APPLICATION REF: P/2014/0672

**PLANNING APPLICATION: CONSTRUCT AND OPERATE SEVEN WIND TURBINES WITH A MAXIMUM TIP HEIGHT OF 110m AND MAXIMUM HUB HEIGHT OF 69m TOGETHER WITH ANCILLARY DEVELOPMENT COMPRISING SUBSTATION, CONTROL BUILDING, NEW AND UPGRADED ACCESS POINTS AND TRACKS, HARDSTANDING AND TEMPORARY COMPOUND AND ASSOCIATED WORKS, AT LAND EAST OF LLANDRINDOD WELLS, SOUTH OF PENYBONT, LLANDEGLEWY, POWYS.**

We write on behalf the applicant Hendy Windfarm Limited in response to selected submissions received by Powys County Council and posted on the planning application page on the Powys planning website.

Wireframe. View from Graig Camp towards Llandegeley Hillfort

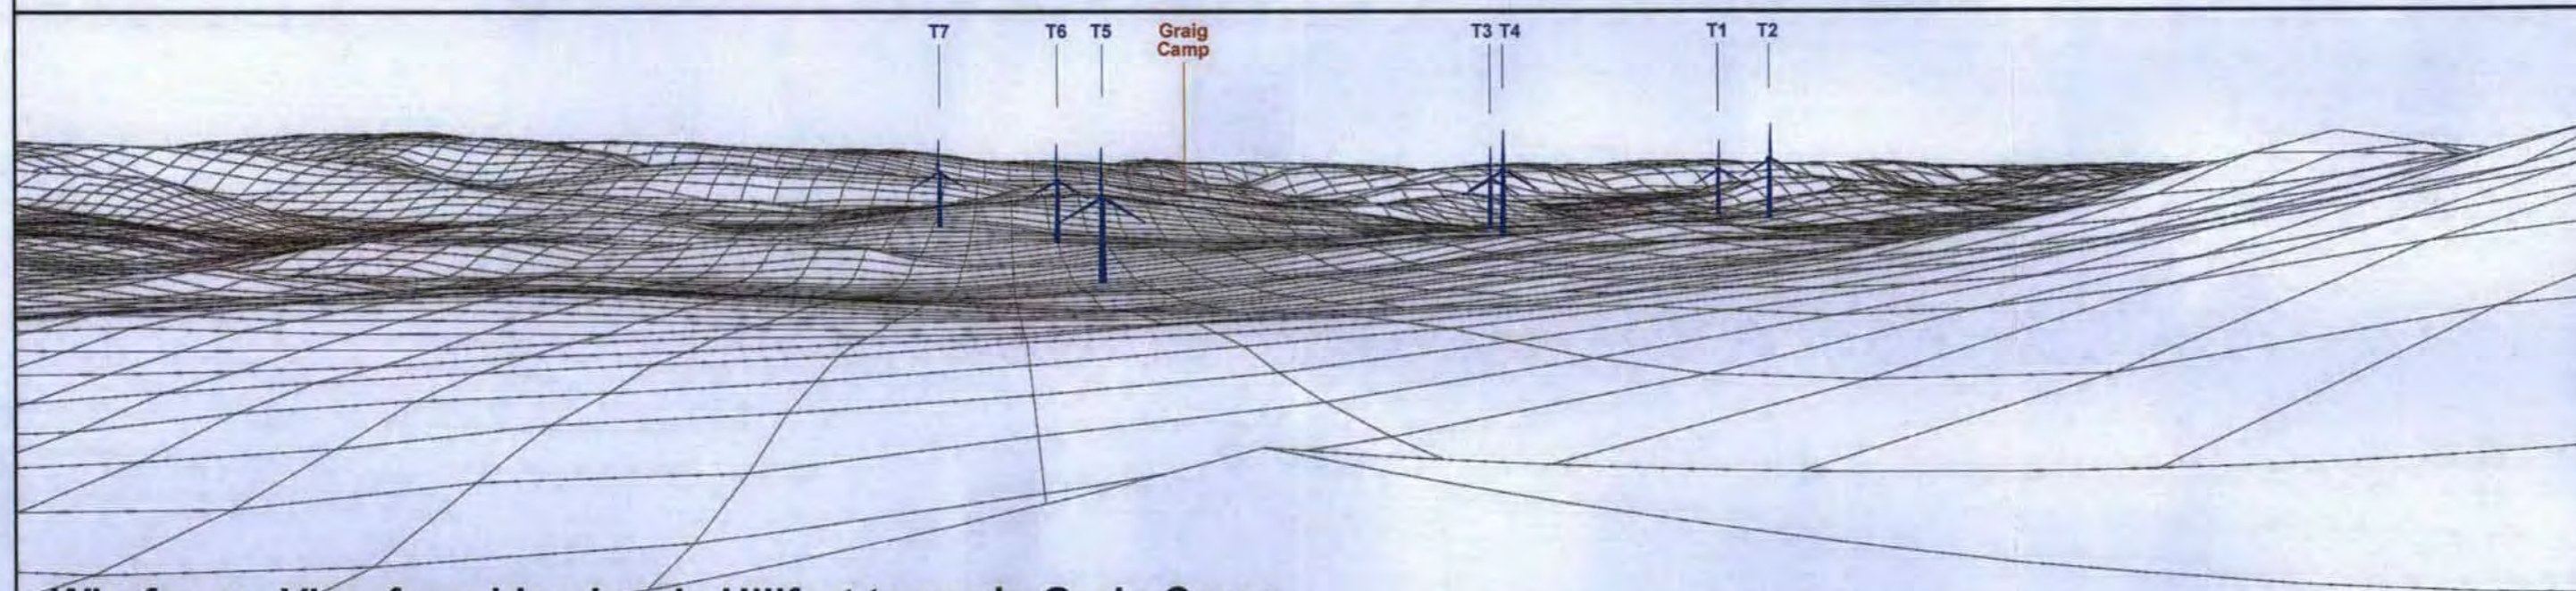
- A photomontage was not deemed necessary, as wireframes produced to inform the assessment indicated that neither monument would be completely obscured by the turbines in the view from the other monument, and as such the change would not constitute "comprehensive changes to the setting" of either monument. We include as Appendix D a pair of wireframes illustrating the intervisibility of monuments RD112 and RD264 and indicating the extent of visibility of the proposed turbines between the sites.

- Cadw are once again assessing this impact as 'major'. The key sentence in this final paragraph is "views between the two monuments...would be substantially interrupted". The views will be interrupted, but **not completely obscured**. As above: The methodology set out within our desk-based assessment states that a 'major' impact causes "Change to most or all key archaeological materials, such that the resource is totally altered", or "Comprehensive changes to setting". The proposed development will not cause "comprehensive" changes to the views between this monument and Llandegley Rocks Hillfort, as the view will not be completely obscured. In addition Cadw's assessment of "major" fails to take into account the reversibility of the impacts with the decommissioning of the turbines and therefore we would contend that it is therefore not in line with Paragraph 2.7.43 of National Policy Statement for Renewable Energy Infrastructure 2011 (EN-3). Taking these points into account we consider that the potential impact to the inter-visibility of these two Scheduled Monuments is at worst 'moderate'.
